One valve, one elbow

Orbit 3/4" electric anti-siphon valve — master valve and backflow protection in a single body, \$18.34. Replaces the plain Orbit already on the wall and reuses the B-Hyve wiring that's already run to it.

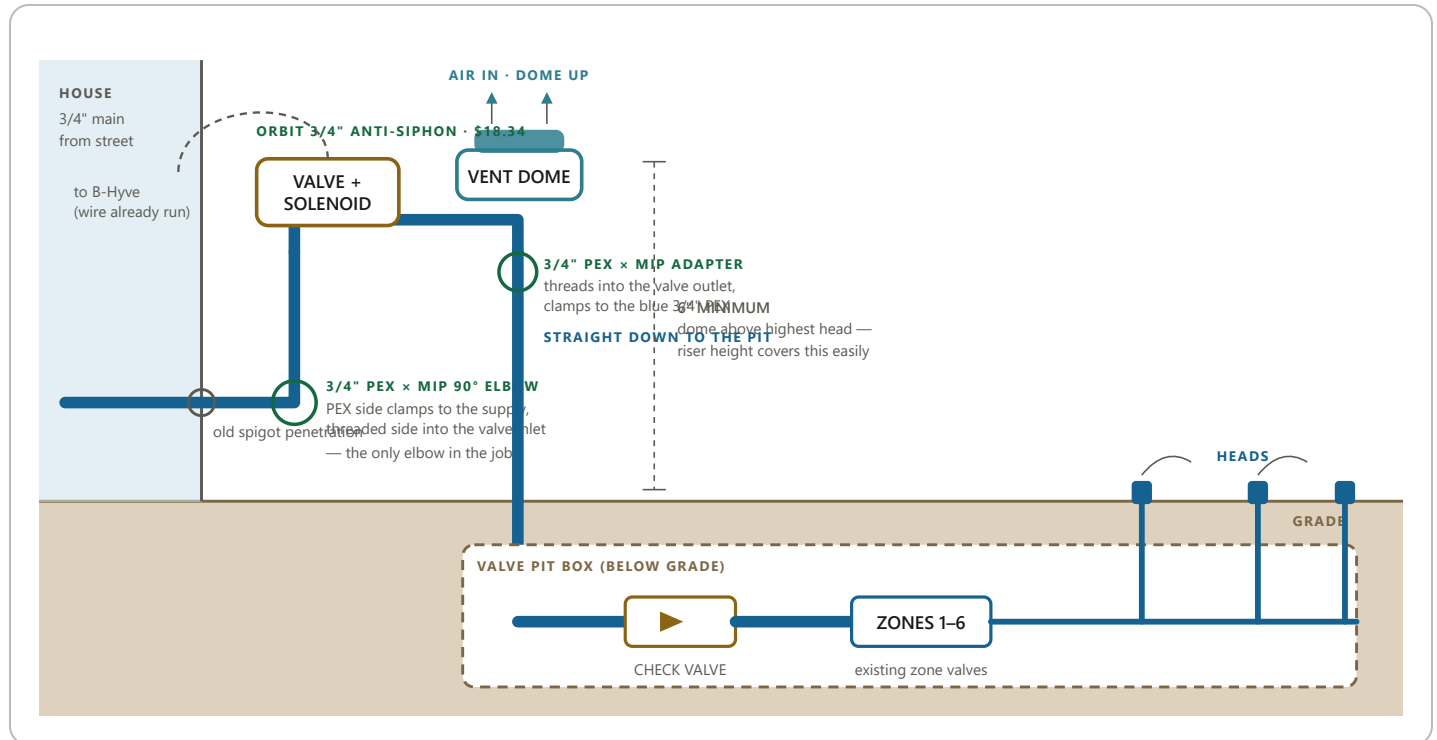
- **One part, not two.** The anti-siphon valve is the master valve and the backflow device in a single body. The earlier layout used your existing valve plus a separate breaker — two bodies, extra threads, extra fittings between them.
- **One elbow, not three.** The valve carries the flow up its inlet leg, across, and back down its outlet leg. Those turns happen inside the casting, so the only fitting you add is the 90 coming off the wall.
- **The vent is downstream of the valve seat by design.** Close the valve and the breaker is unpressurized — the continuous-pressure rule is satisfied by how the thing is built, not by arranging parts in a particular order.
- **Drop-in.** It replaces the plain Orbit already on that stub, and the B-Hyve wiring is already run to that exact spot for the existing solenoid.

- **Dome up, above grade.** Non-negotiable — the poppet has to fall open on gravity.
- **Follow the cast arrows.** Inlet leg from the riser, outlet leg down to the PEX. Backwards, it won't protect anything.
- **Brace it.** The valve sits at the top of a riser and the PEX shouldn't carry its weight.
- **It's above ground.** Same freeze exposure as what's on that wall today, so treat it the same way at winterization.

Your six zone valves are still shutoff valves **downstream** of an atmospheric breaker, which the standard doesn't strictly allow. That's unchanged from every layout we've looked at — no better, no worse. The by-the-book alternative is a pressure vacuum breaker at roughly \$80–150, plus annual testing by a licensed tester, which is exactly the attention you're trying not to attract. The **check valve in the pit** is a useful second layer but isn't a listed preventer on its own.
